Local Planning Panel

Address: 117 Victoria Street, Potts Point

Application Number: D/2024/524

The application is recommended for refusal

15m height plane shown in red

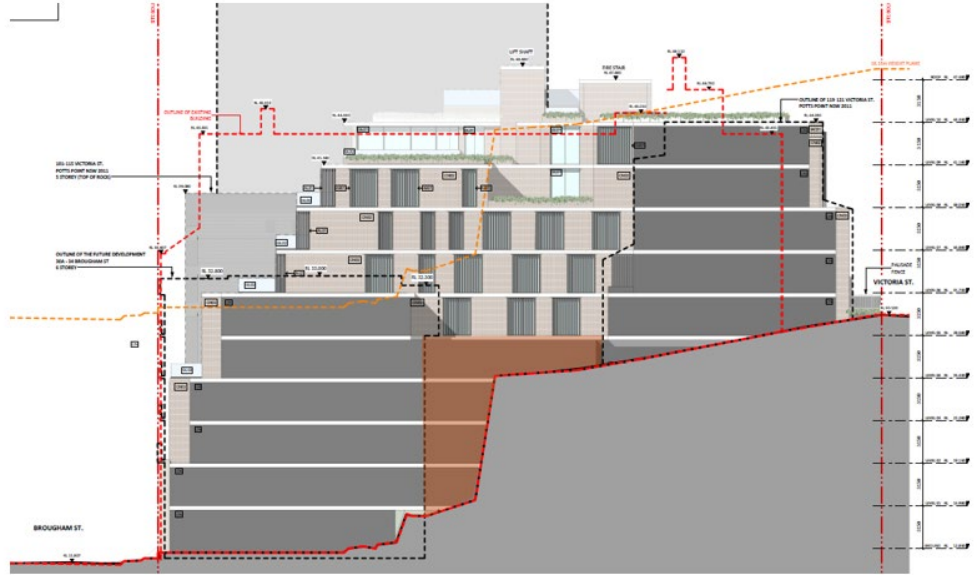
- 65.8% variation to 15m height control
- 20.8% variation to FSR control (no clause 4.6 supplied)
- building not appropriately stepped with topography
